**SUBJECT: RECALL CAMPAIGN #05V144
2005 Scorpion Reflex Reflector Recall**

PRODUCT RECALL SERVICE BULLETIN #PR:05-1

This service bulletin describes the procedure to replace the rear and side marker lights on certain 2005 Scorpion folding trailer with replacements that incorporate reflex reflectors.

PHOTO 1

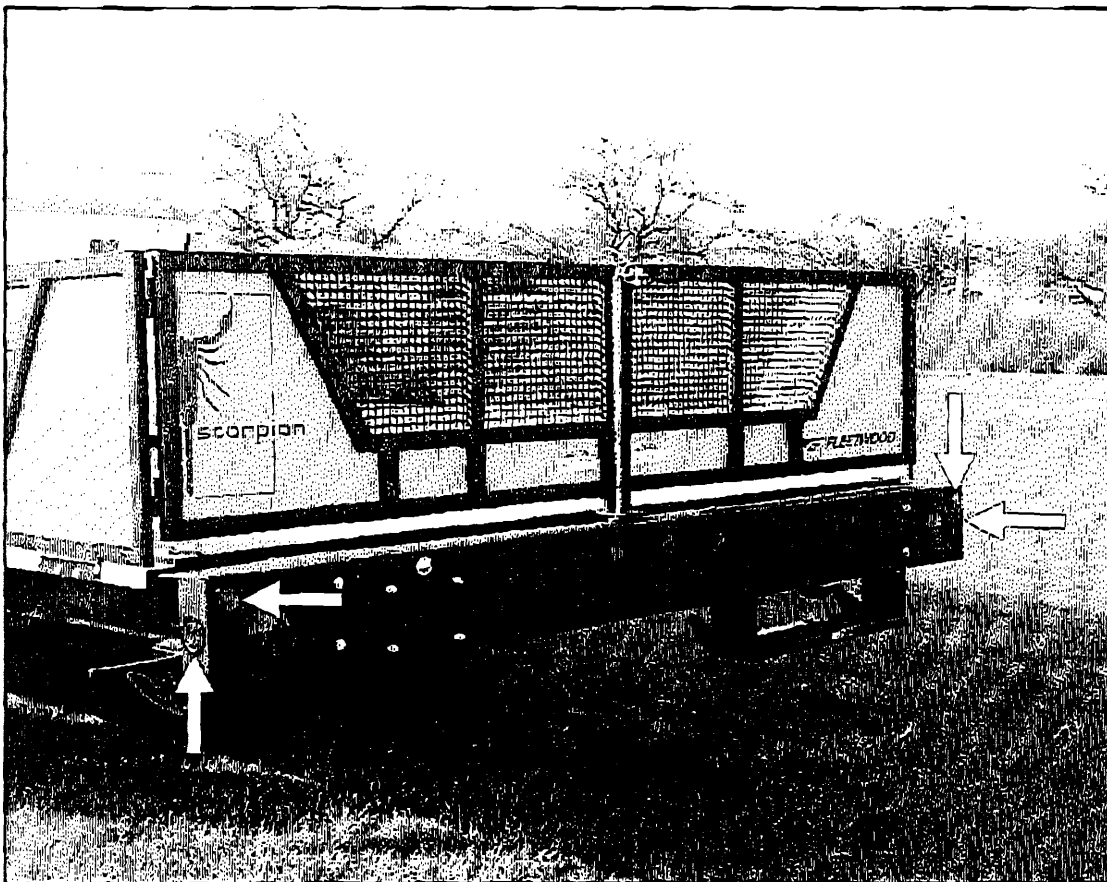
1. Remove the four marker lights from the bumper by removing the inner cover plate and pulling the wire plug from the rear of each light. See photo 1 for the location of the marker lights to be removed.
2. Align the holes in the "aluminum" mounting bracket with the holes in the "black" mounting plate. Attach both parts using two rivets (P/N 4733G060). See photo 2.

PHOTO 2

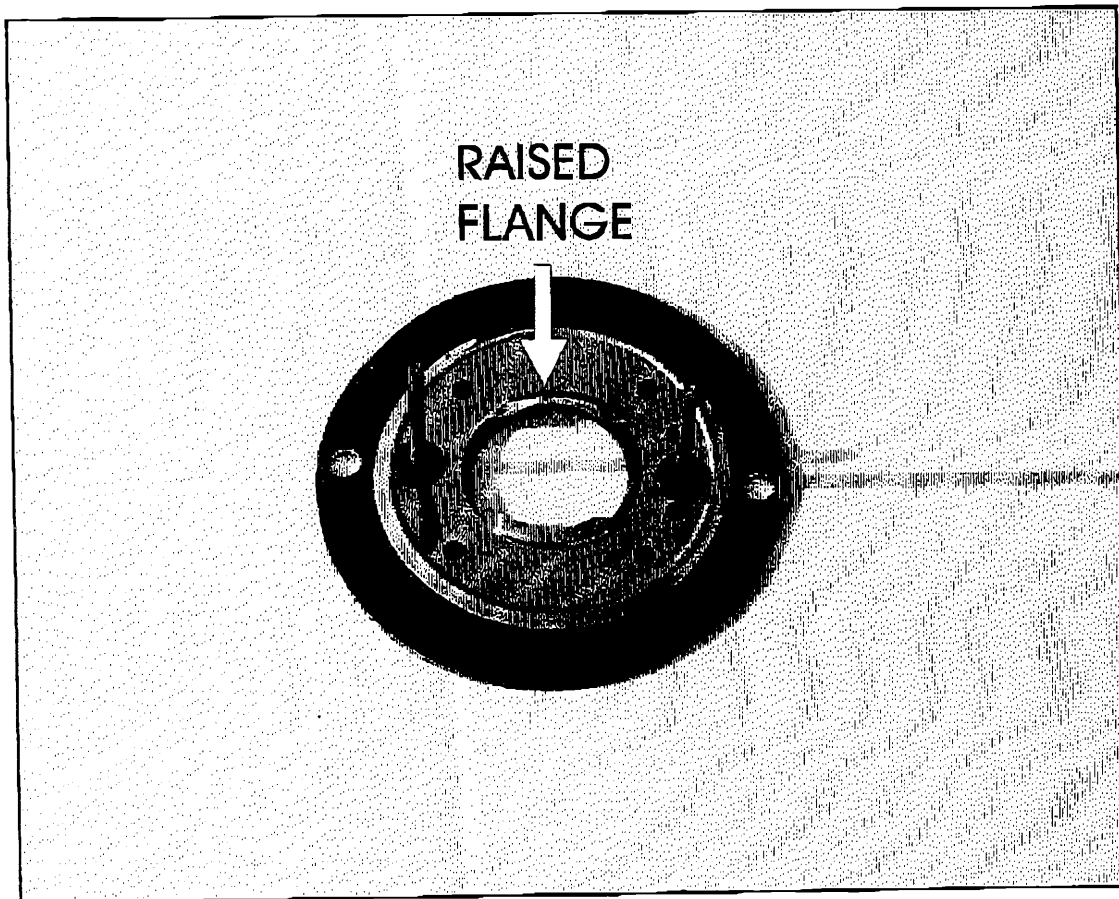
NOTE: Make sure the raised flanges are facing upward.

PHOTO 3

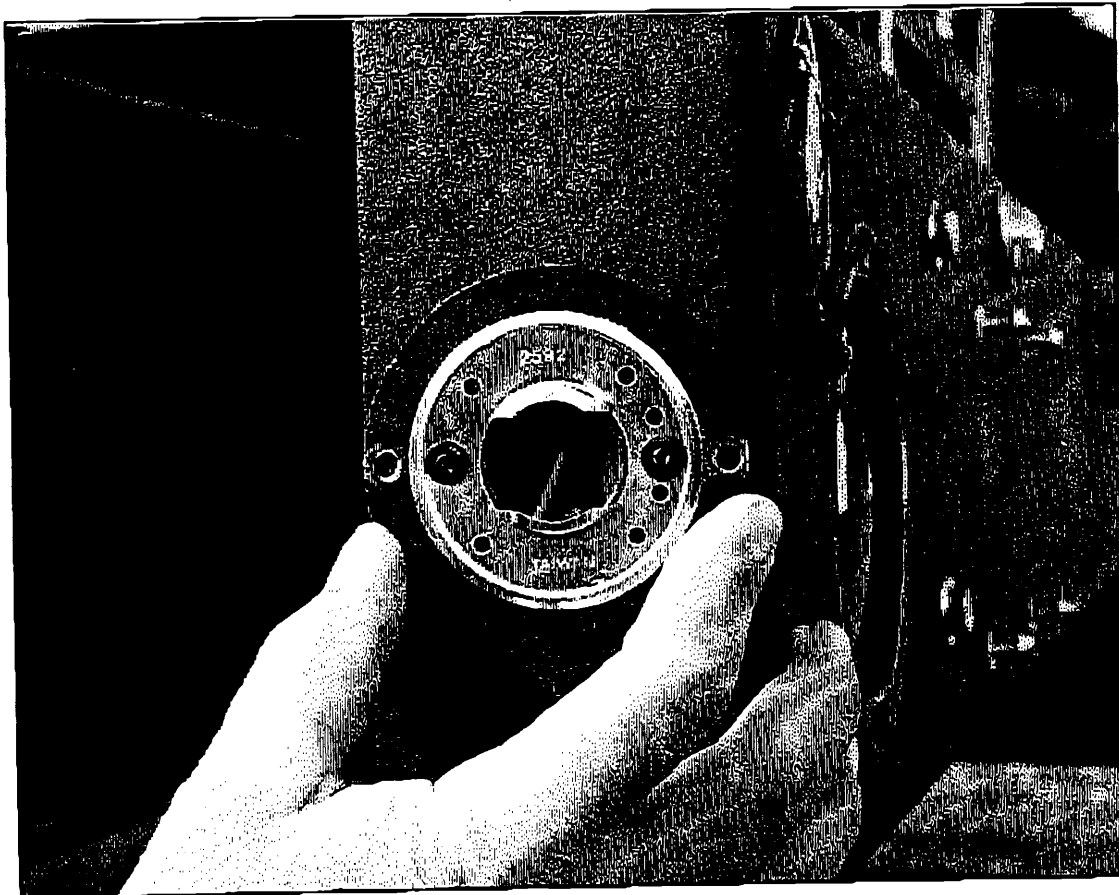
3. Center the mounting plate assembly over the original hole in the bumper. Make sure the original mounting holes are covered by the assembly and mark the holes. See photo 3.

NOTE: Double check the hole locations before drilling to ensure they are not too close to the edge of the bumper.

PHOTO 4

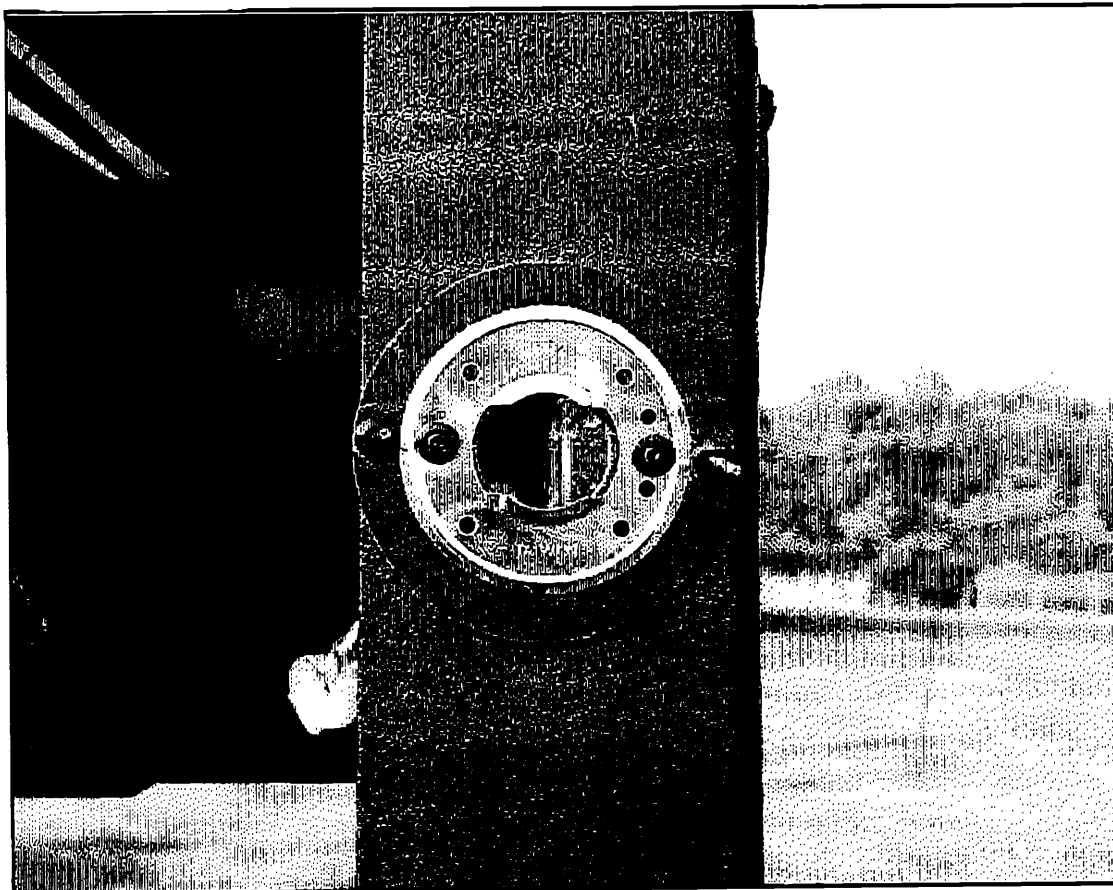
4. Drill two 0.199 diameter holes and attach the mounting plate assembly to the bumper using two rivets (P/N 4734J186). See photo 4.
5. Install the reflex reflector marker light to the bracket by inserting the light into the raised flanges and turning clockwise. Turn until the light is tight in the mounting plate assembly.
6. Reattach the wire plug to the back of the new light.
7. Repeat steps 1 - 6 for the other lights indicated in photo 1.
8. Check the function of all the lights.
9. Reinstall both inner cover plates.
